CITY OF HASTINGS

ADDENDUM NO. 2

Museum Air Handler Replacement

Contract No. CH 2025-36

SECOND FLOOR
PLAN - ELECTRICAL

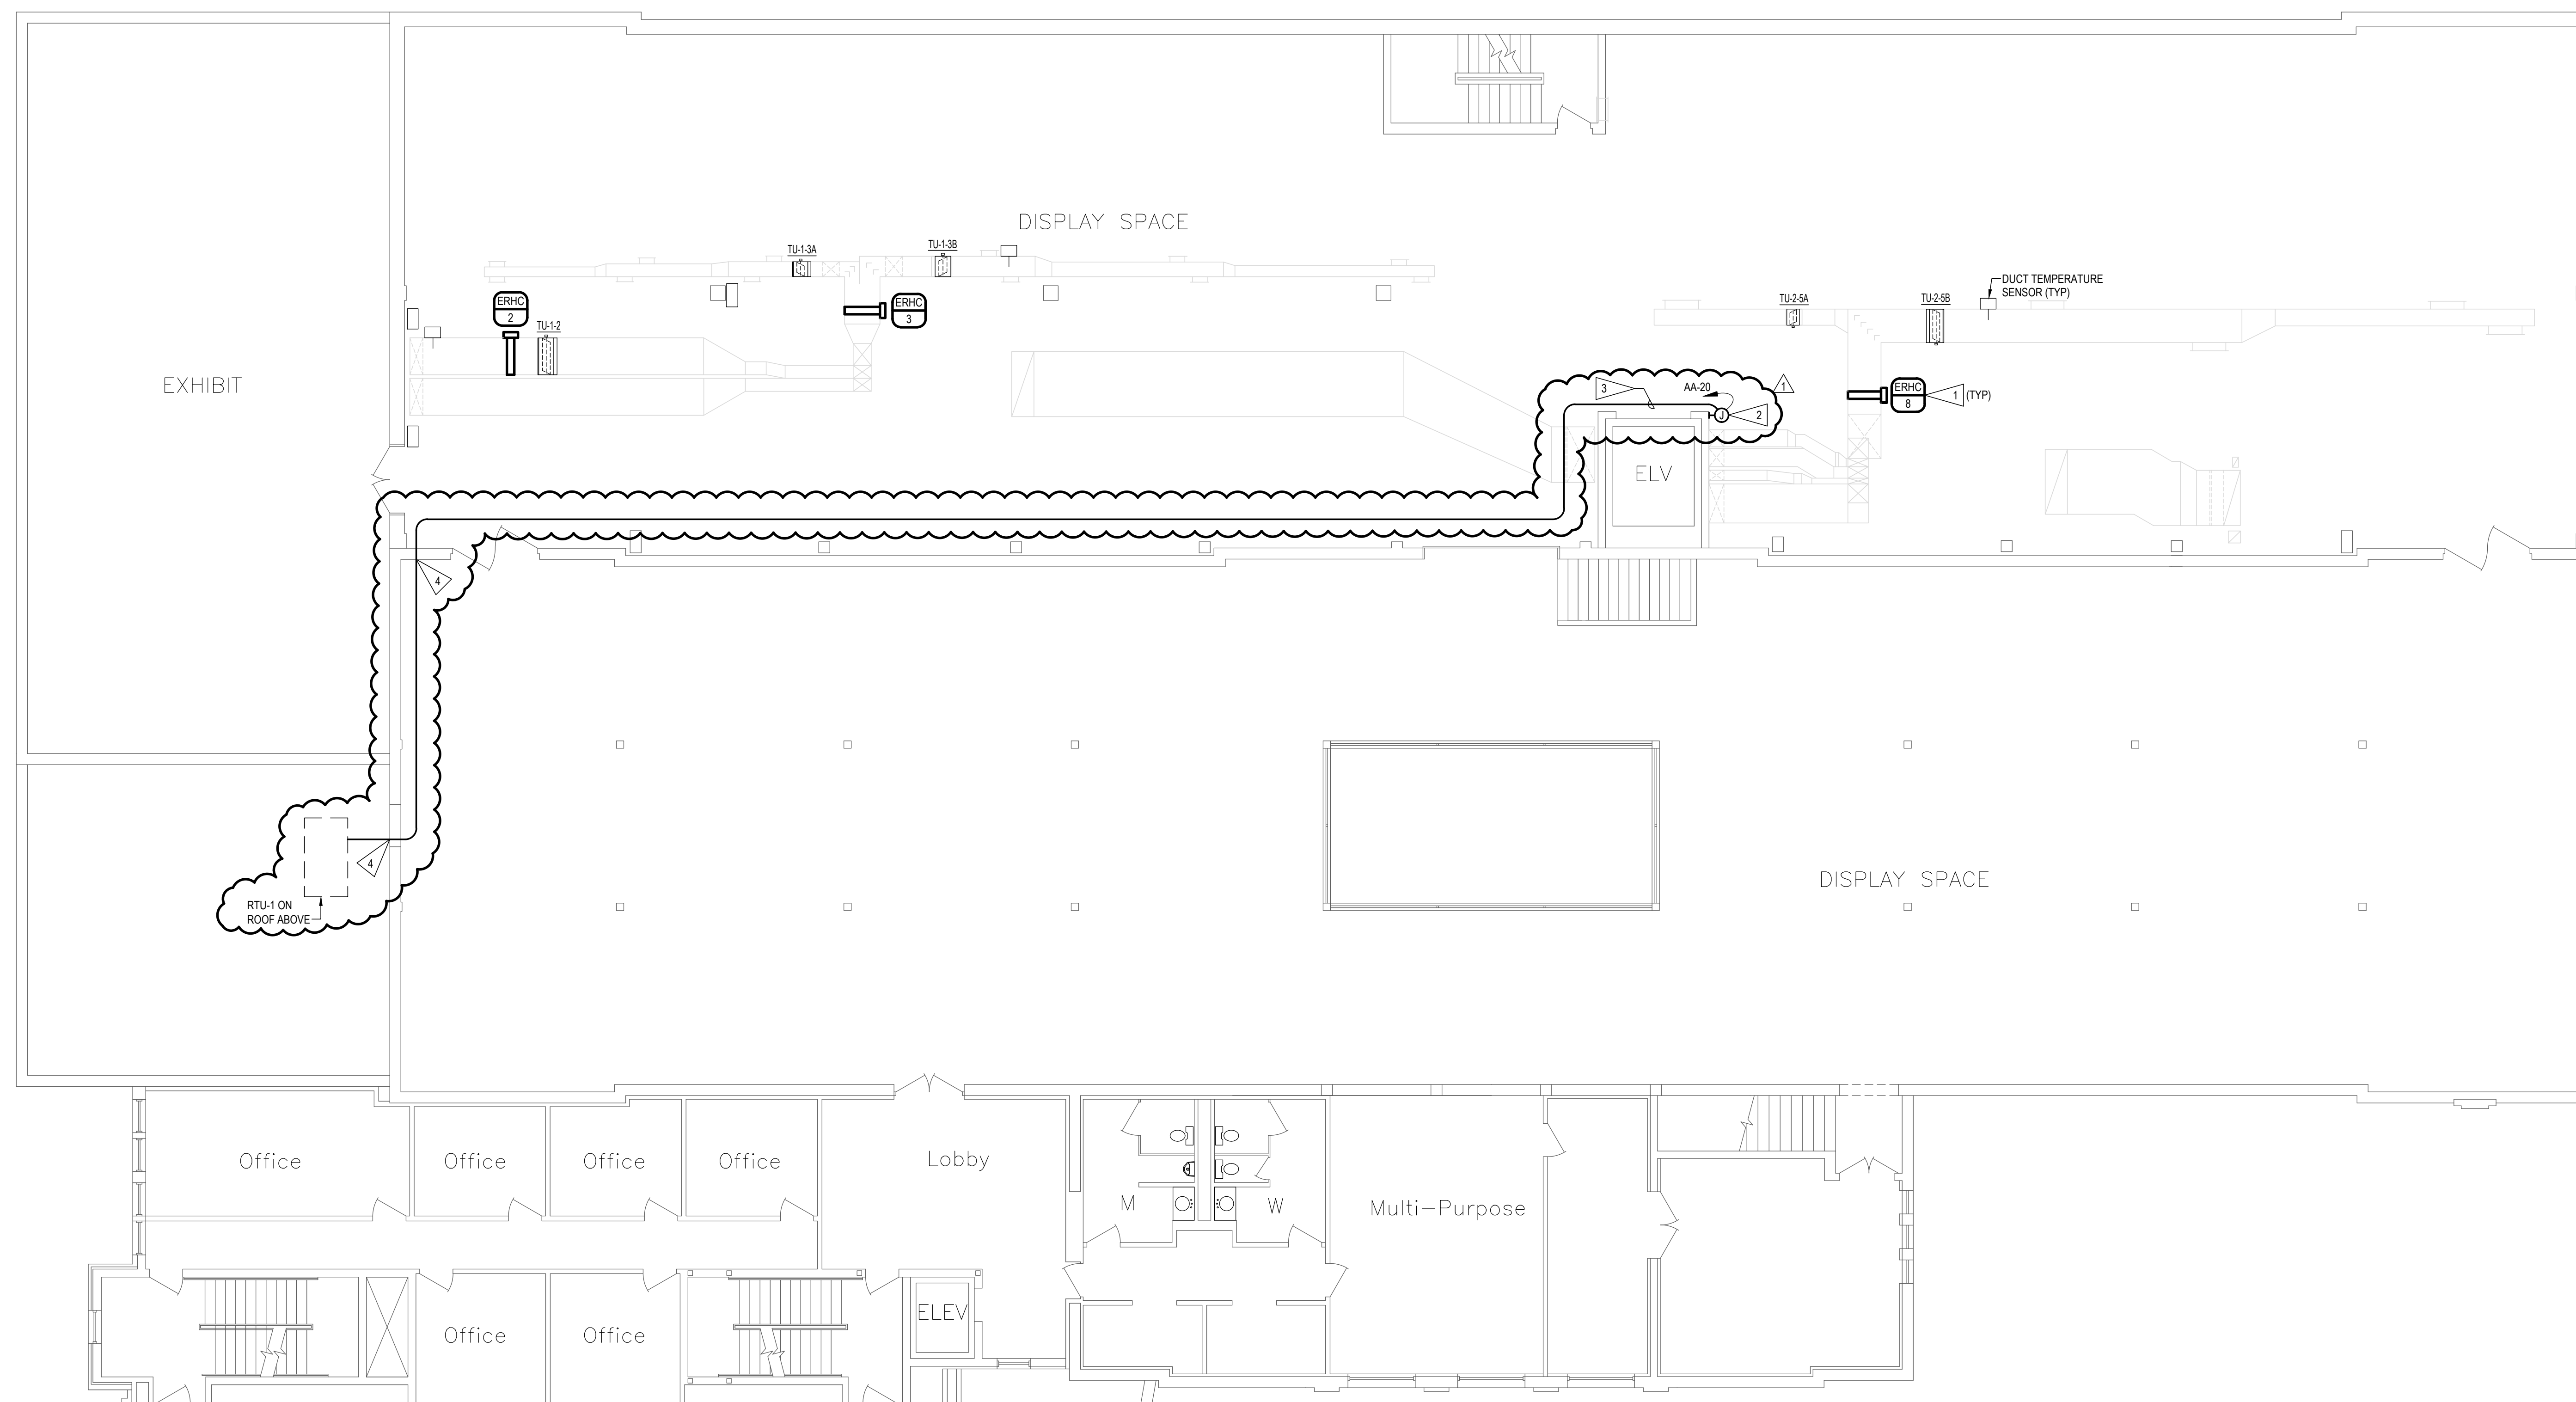
1ED6. Sheet E1.3 – Second Floor Plan – Electrical

1. Add the existing humidifier H-8 location and associated circuit. Extend the existing circuit to serve new RTU-1.
2. Add Flag Notes 2, 3, and 4.

THIRD FLOOR
PLAN - ELECTRICAL

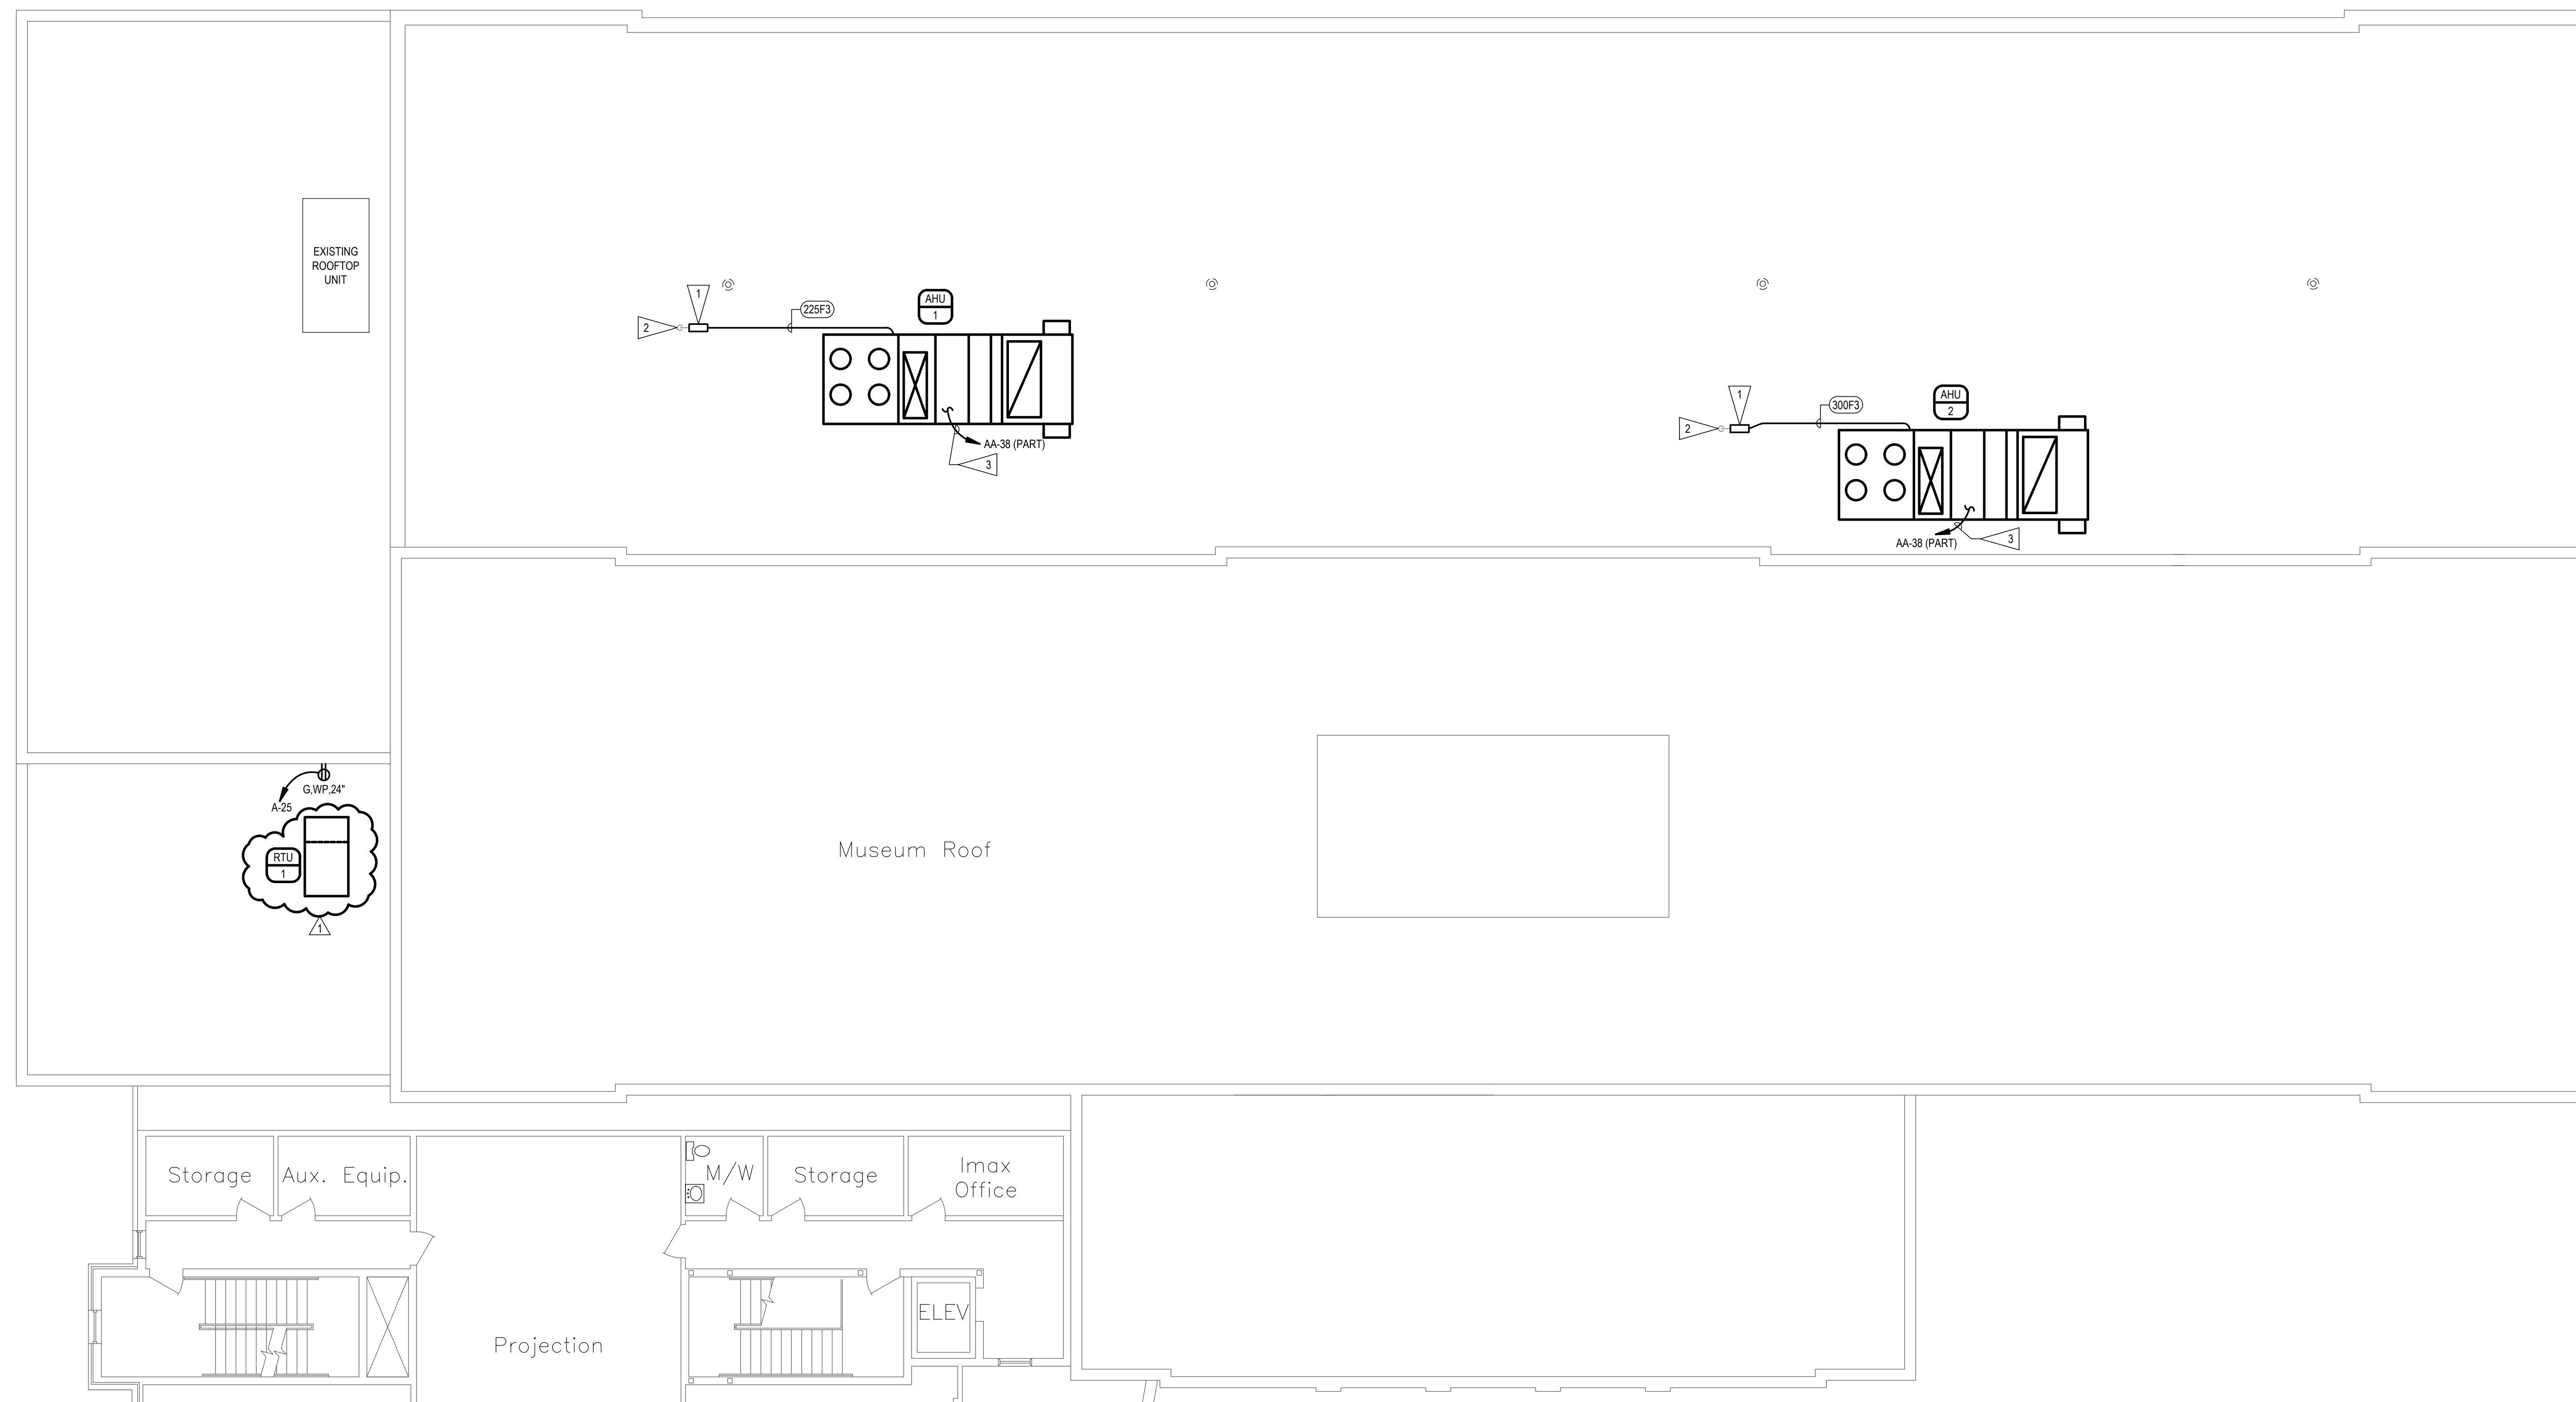
1ED7. Sheet E1.4 – Third Floor Plan – Electrical

1. Delete ACCU-1.
2. Add RTU-1.
